UNITED STATES PATENT AND TRADEMARK OFFICE

Office Action Summary	Application No. 10/707,416	Applicant(s) LEE ET AL	
	Examiner Tarifur R. Chowdhury	Art Unit 2871

DETAILED ACTION

FIG. 1

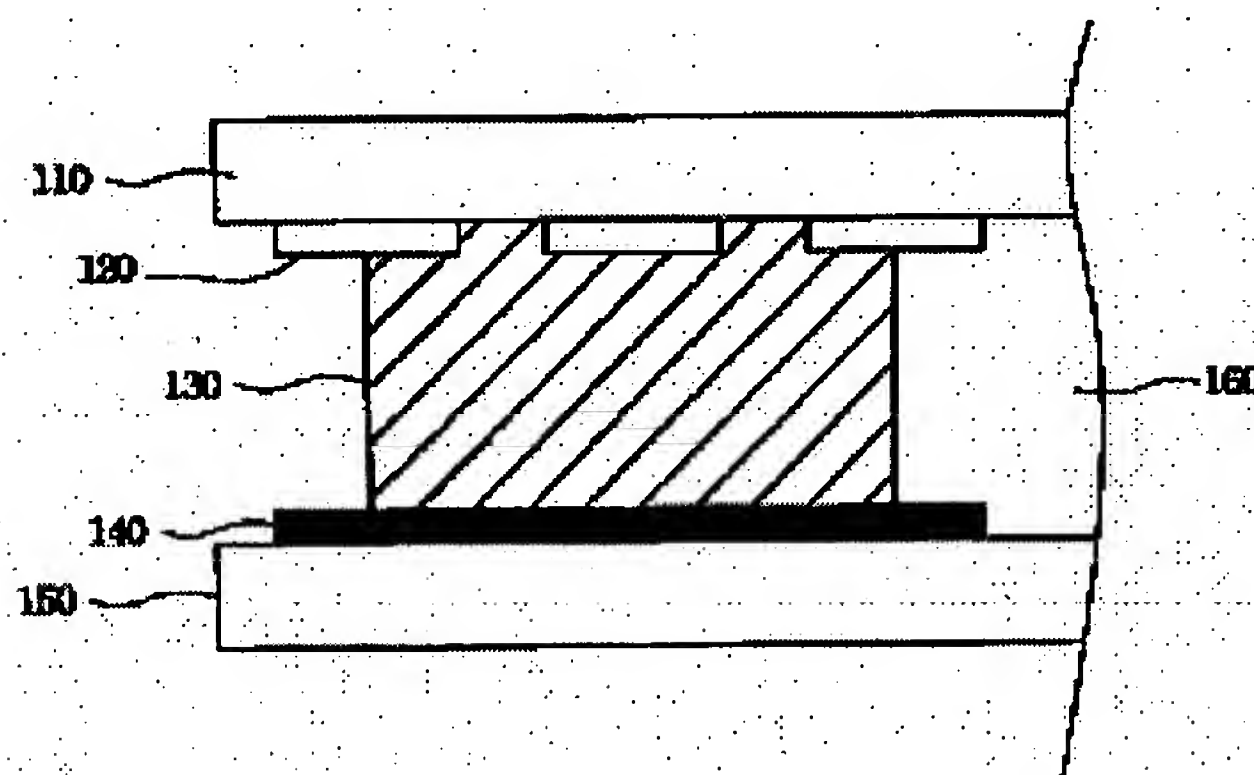
8. Lee discloses (page 1, paragraph 0010; page 2, paragraph's 0021-0024) and shows in Fig. 1, a one drop fill (ODF) liquid crystal display (LCD) panel comprising::

- a first substrate (150) comprising:

- a pixel array region (not shown) positioned on a central part of the first substrate (150);
- a sealant region positioned on a bordering part of the first substrate and surrounding the pixel region; and
- a metal light-shielding pattern (140) positioned on a surface of the sealant region;

- a second substrate (110);
- a sealant pattern (130) positioned between the first substrate and the second substrate and corresponding to the sealant region for combining the first substrate with the second substrate; and
- a liquid crystal layer (160) positioned between the first substrate and the second substrate.

Accordingly, claims 1, 8-11 and 18-21 are anticipated.

As to claims 2 and 12, Lee also discloses that the sealant pattern (130) is UV type (page 2, paragraph 0022) (applicant's photocuring sealant).

FIG. 4

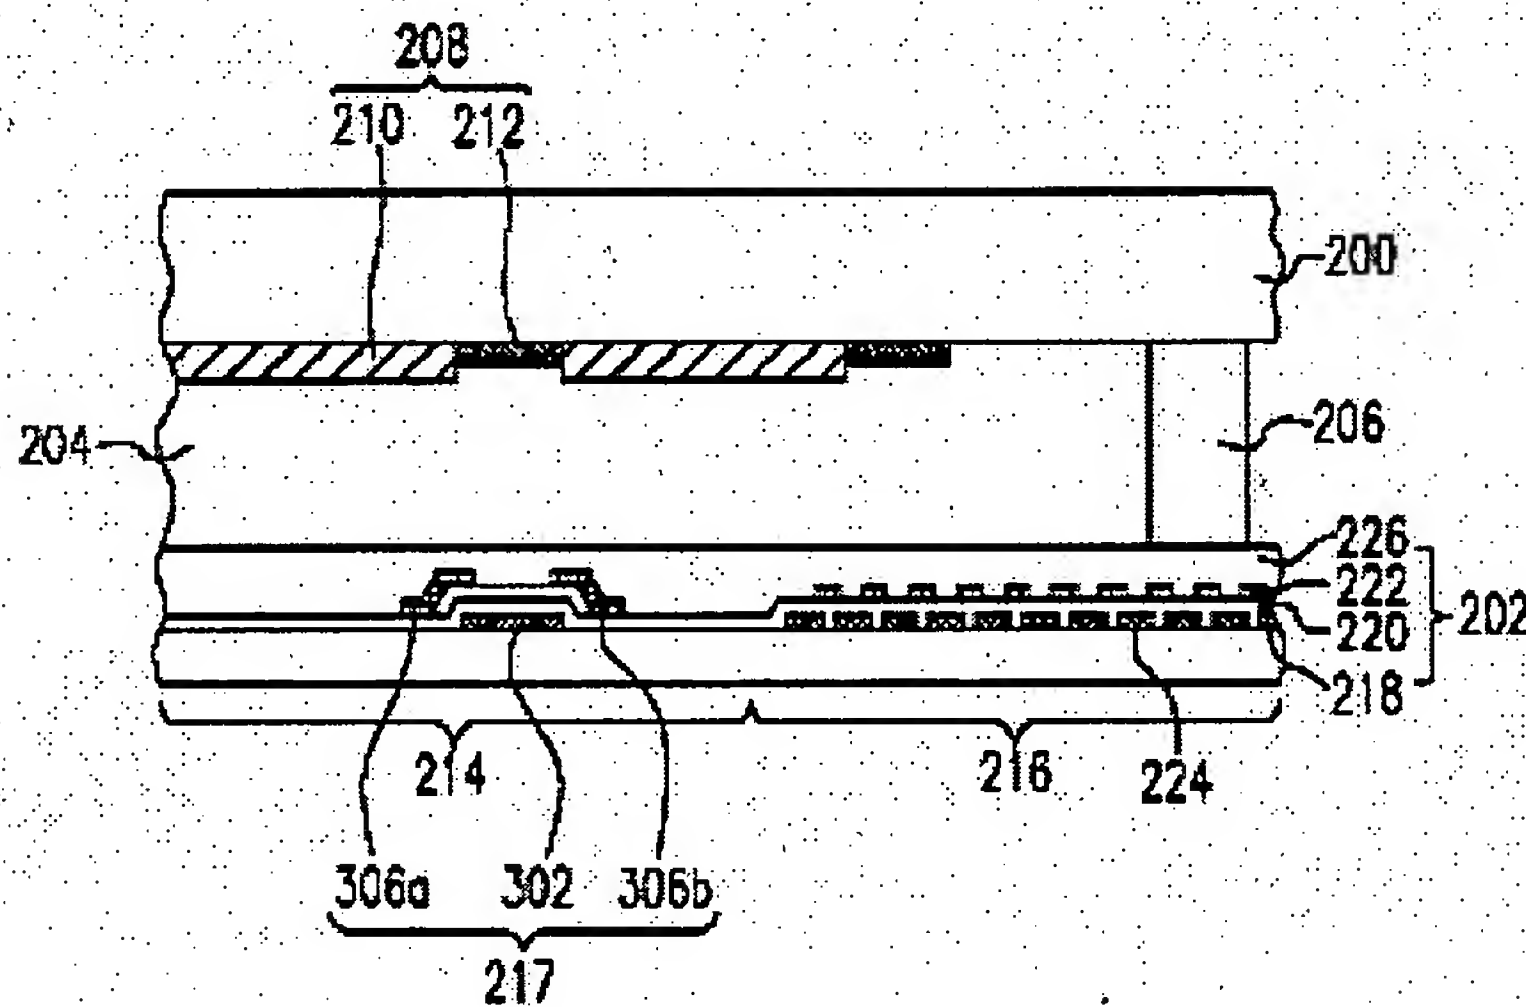
11. Chu discloses and shows in Fig. 4, a one drop fill (ODF) liquid crystal display (LCD) panel comprising:

- a first substrate (202) comprising:
- a pixel array region (214) positioned on a central part of the first substrate;

- a sealant region (216) positioned on a bordering part of the first substrate and surrounding the pixel region; and

- light-shielding patterns (222, 224) positioned on a surface of the sealant region (216)
- a second substrate (200);
- a sealant pattern (206) positioned between the first substrate and the second substrate and corresponding to the sealant region for combining the first substrate with the second substrate; and
- a liquid crystal layer (204) positioned between the first substrate and the second substrate.

Accordingly, claims 1, 8-11 and 18-21 are anticipated.

As to claims 2 and 12, Chu also discloses that the sealant pattern (206) is fabricated from an UV photosensitive material (page 3, paragraph 0036) (applicant's photocuring sealant).

As to claims 3, 4, 13, 14 and 17, Chu also discloses and shows in Fig. 4, that the light shielding pattern is for preventing light leakage through the sealant region (216), the light-shielding pattern comprising a first metal pattern (222), a second metal pattern (224), and a first insulation layer (220) positioned between the first metal pattern and the second metal pattern (Page 3, paragraph 0035) and that the pixel array region (214) further comprises a plurality of pixels arranged in arrays, each pixel including a thin film transistor (217).
